Fw: Request for Final Review of New Construction Proposed at 4126-28 Parkside Ave

Beywatch Property Management LLC
Renovation & Addition

4126-28 Parkside Avenue
Philadelphia, PA 19104

A202

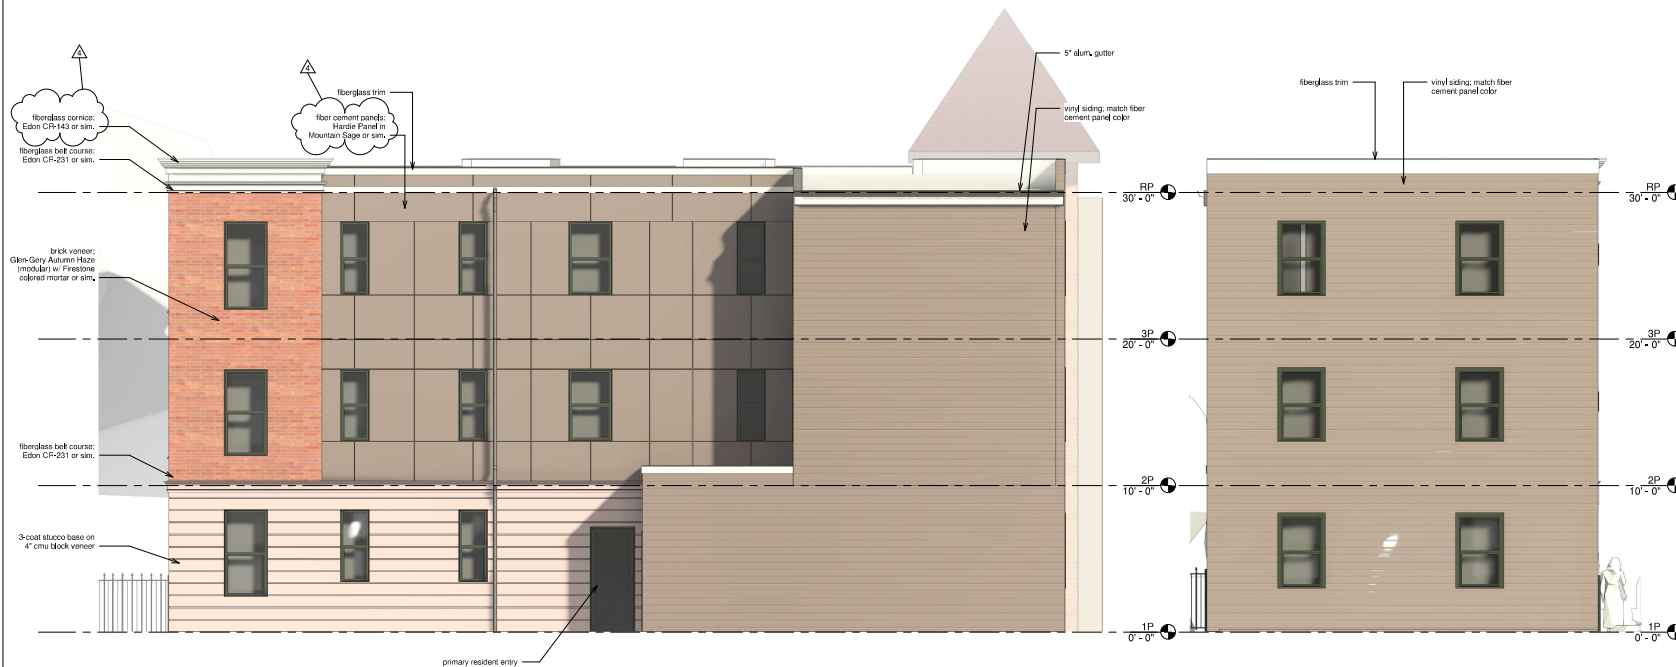
- reduced cornice proportions and lowered parapet
- wrapped brick bay around interior court side
- added rear elevation to A202
- eliminate vinyl siding on East elevation
- darker tone to panelling (we're struggling with this a bit, since it renders differently in every view)
